ROOF REPLACEMENT CAPITAL PLAZA

FRANKFORT, KENTUCKY

REVISION NO. 1 11 APR. 2005

"AS-BUILT" NOTE:

DETAIL D A-7 1/2 F.S.

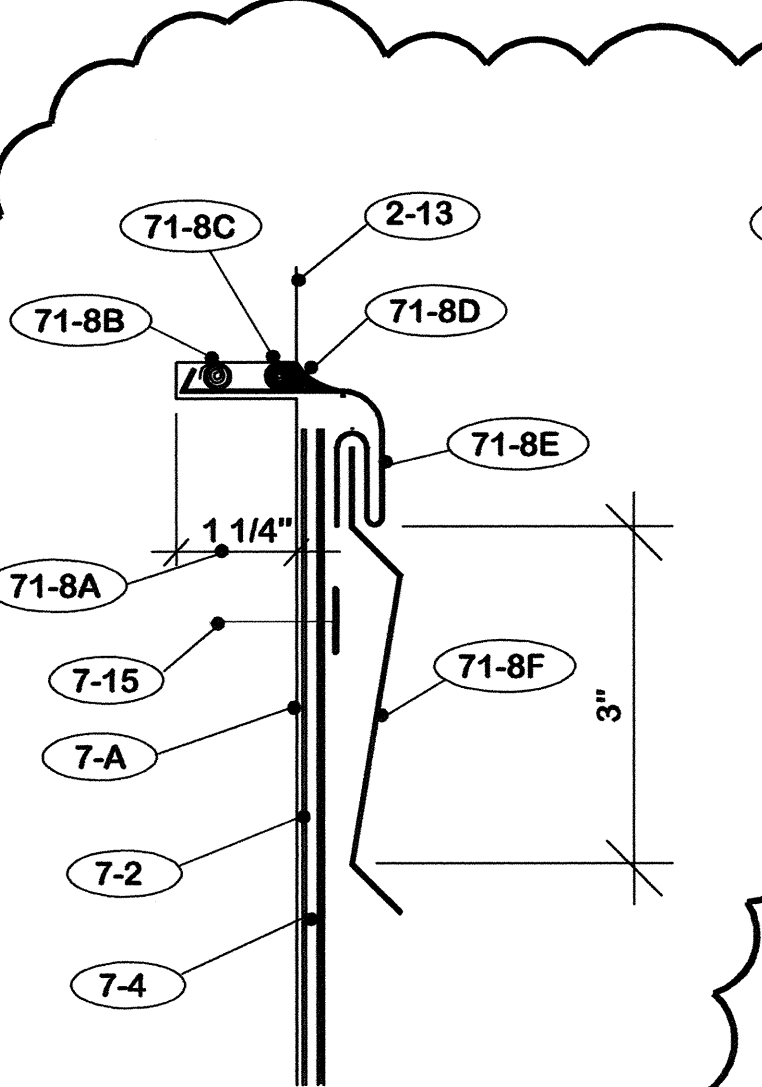
NOTE "A"
 1. Revised Detail F/A-7.
 2. Deleted Detail D/A-7.
 3. Revised Detail E/A-7.
 4. Add Detail H/A-7.
 5. Delete notes 7-8 and 71-8.
 6. Add notes 7-16, 7-17, 7-18, 7-19 & 7-20.
 7. Moved note series 8.

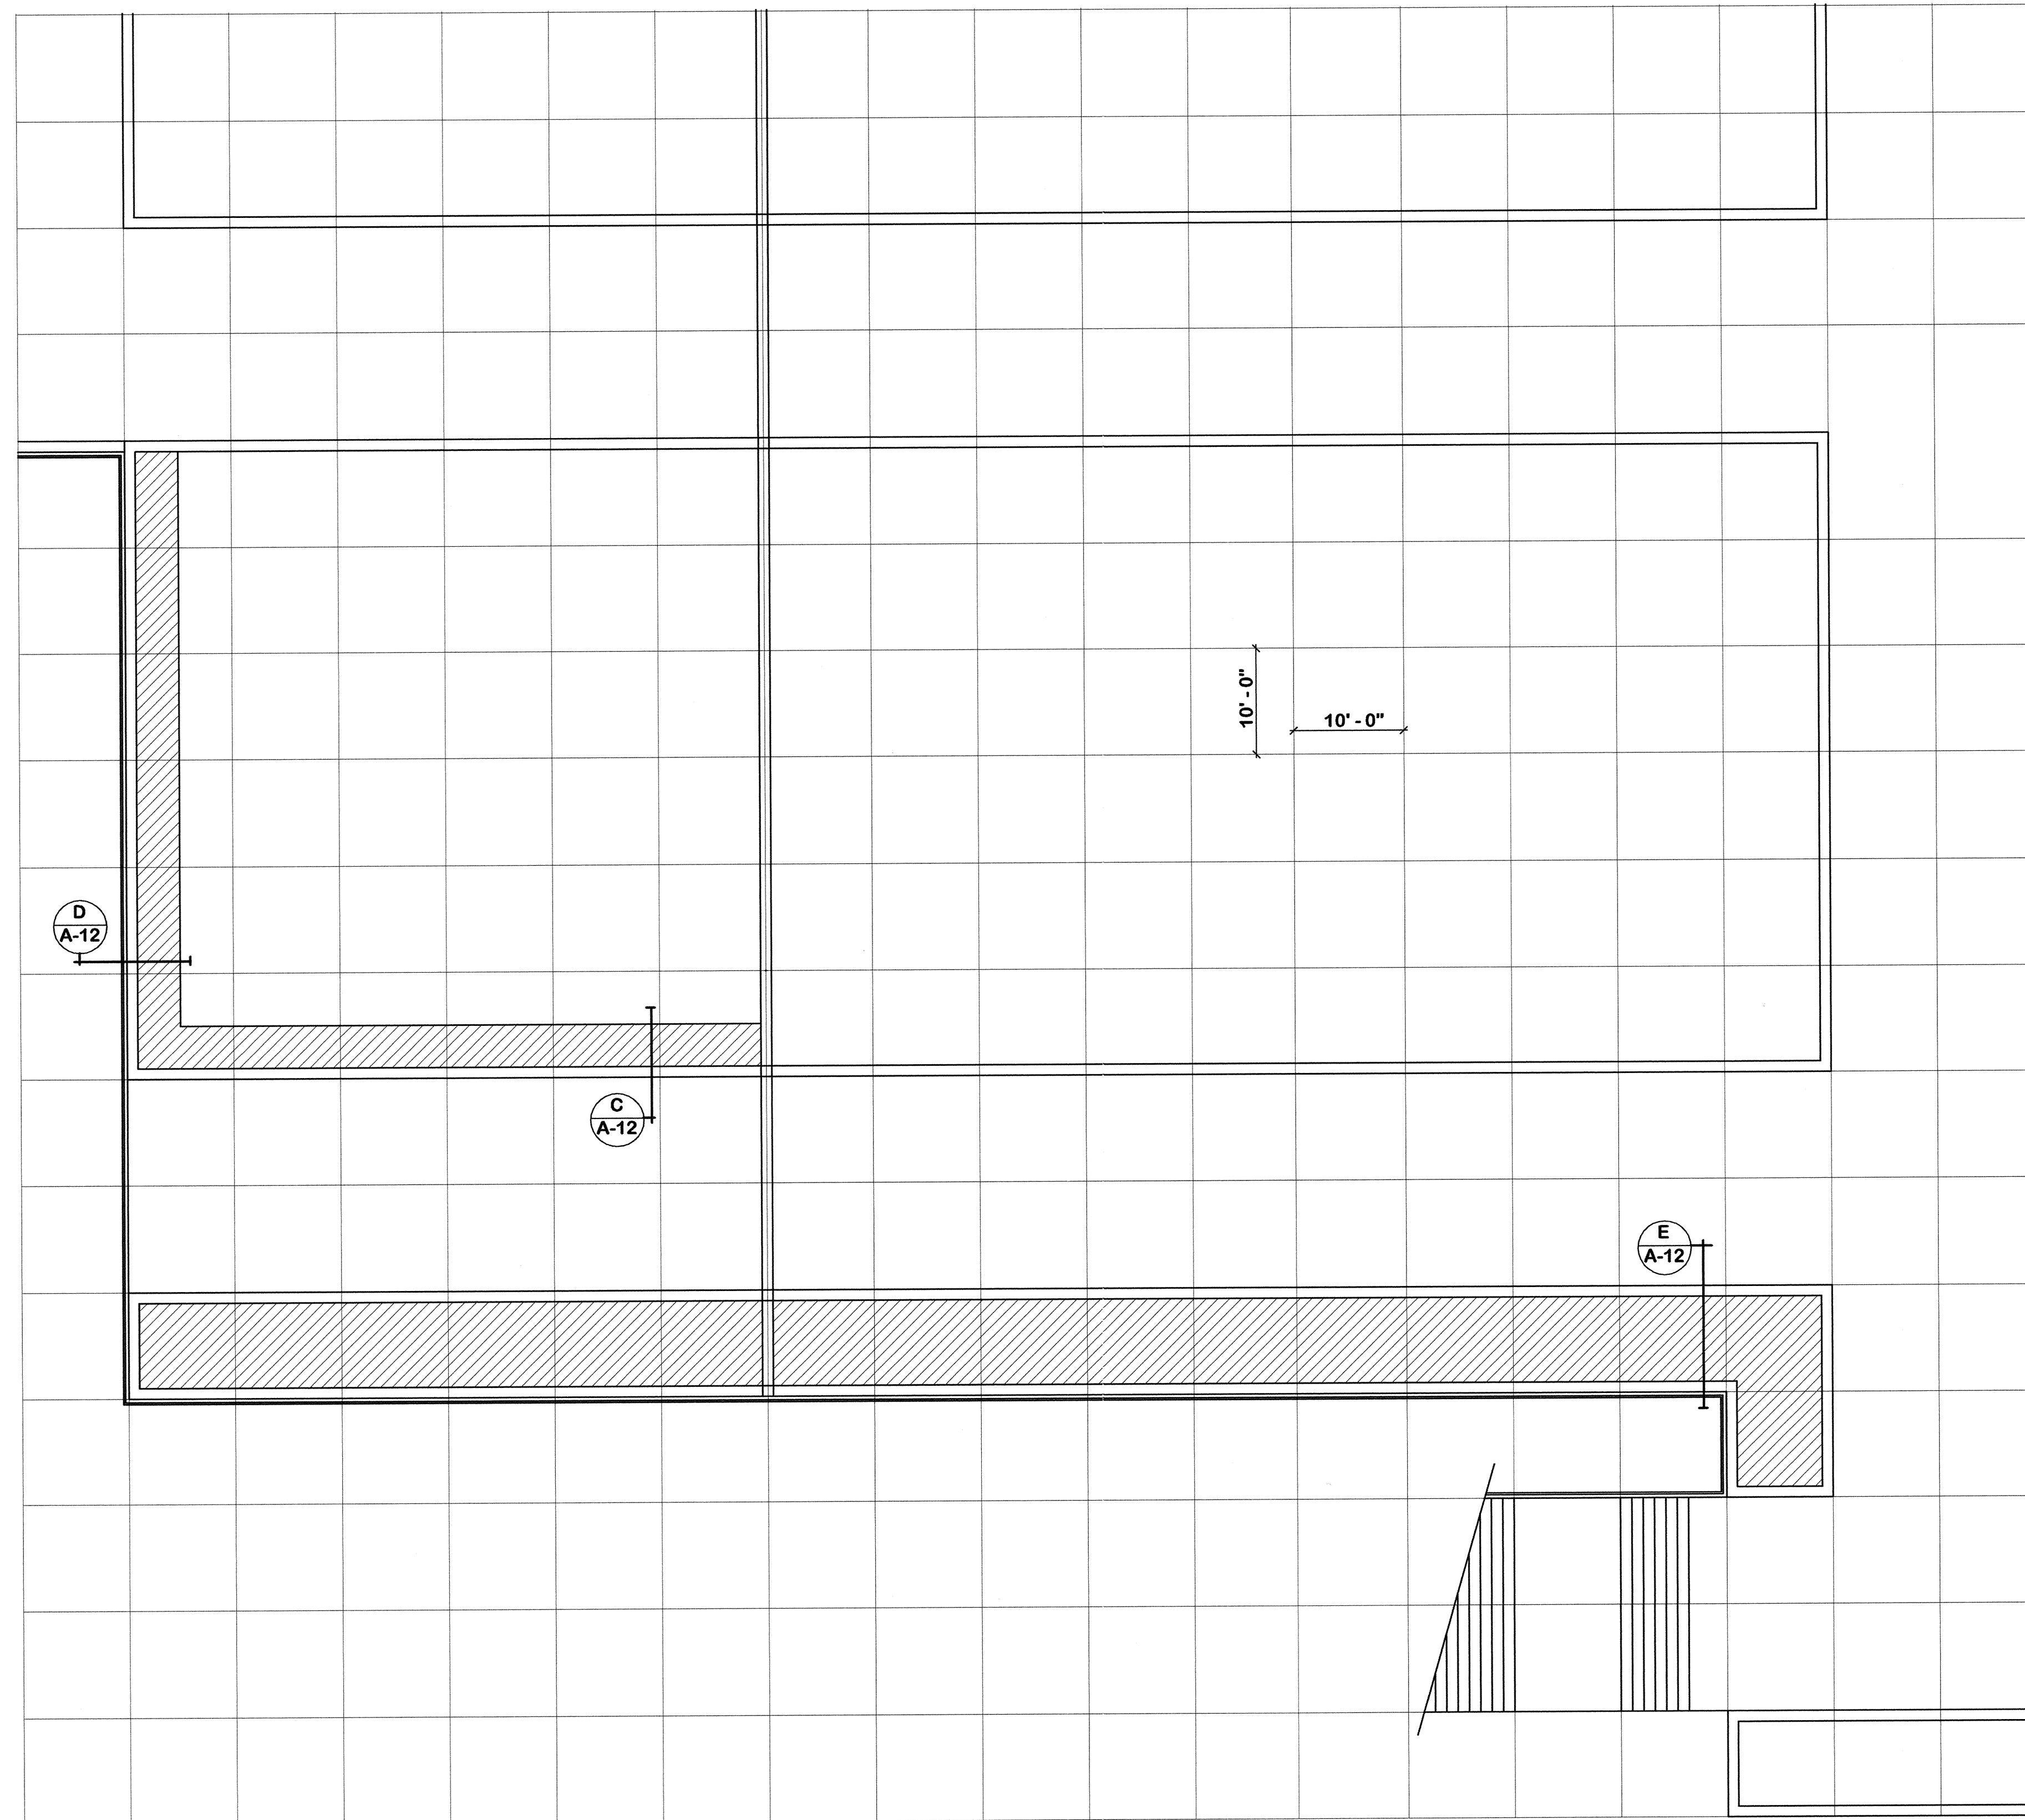
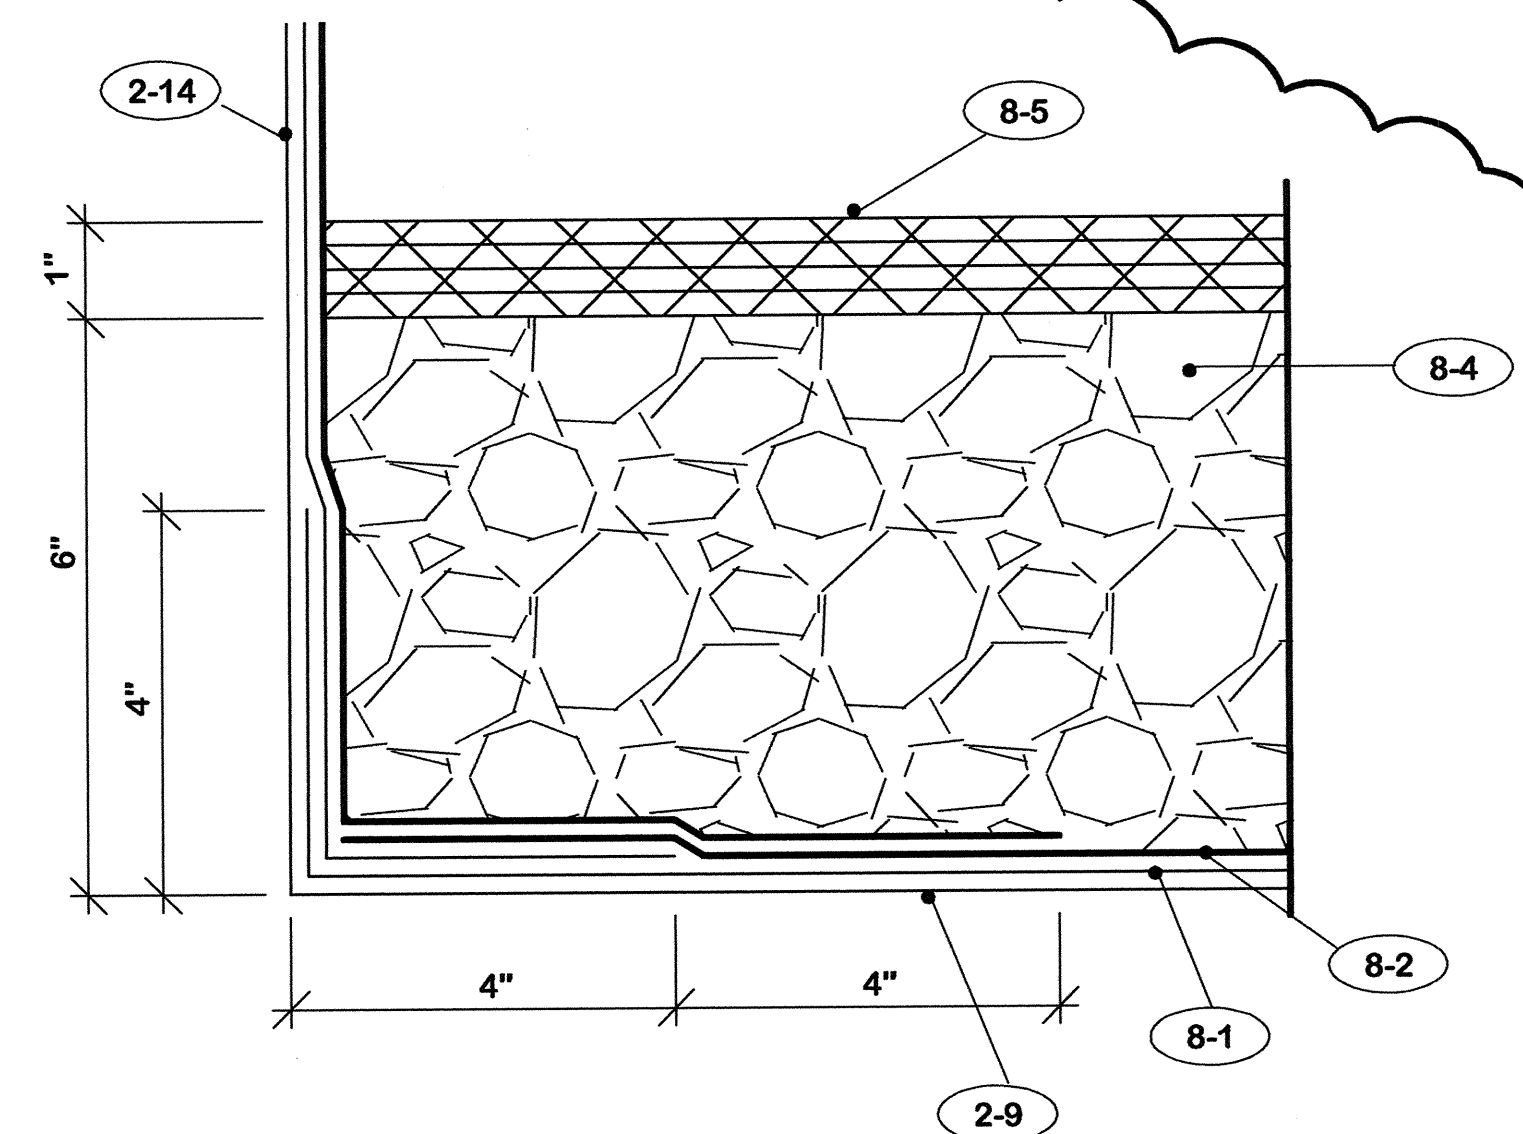
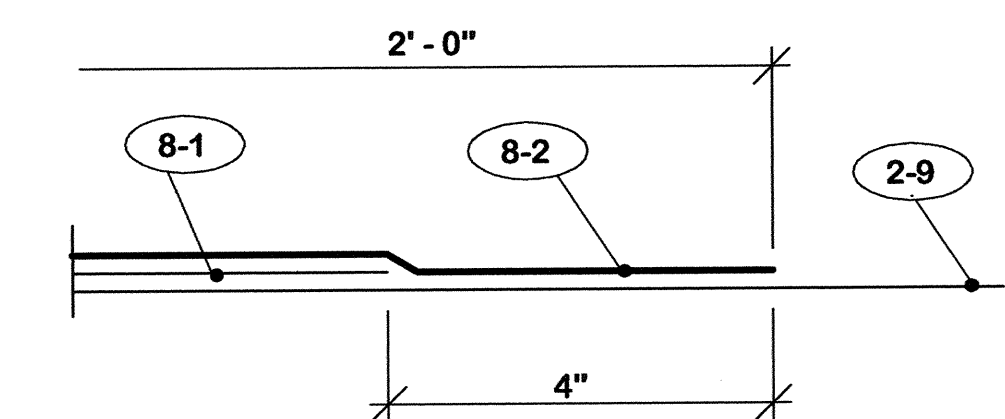
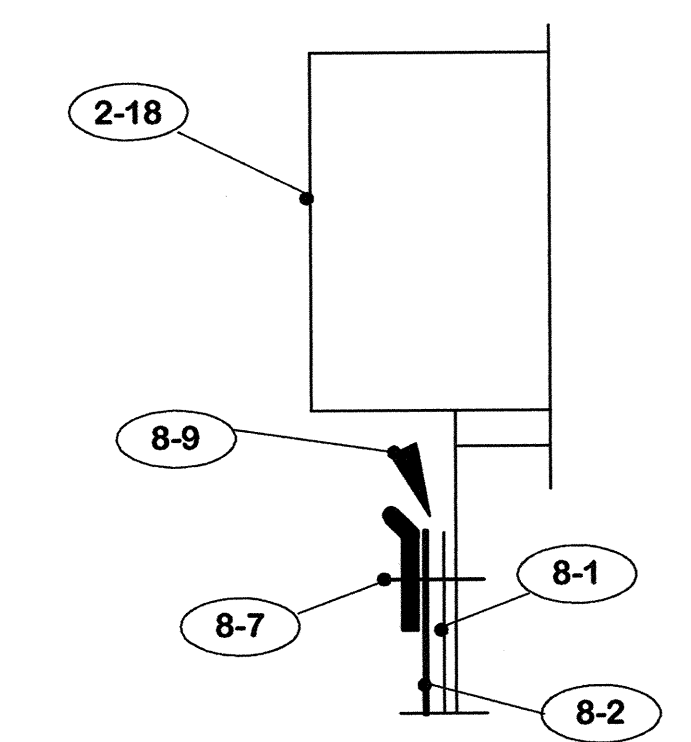
"AS-BUILT" NOTE:
1. This proposed construction was not accomplished due to lack of funding.
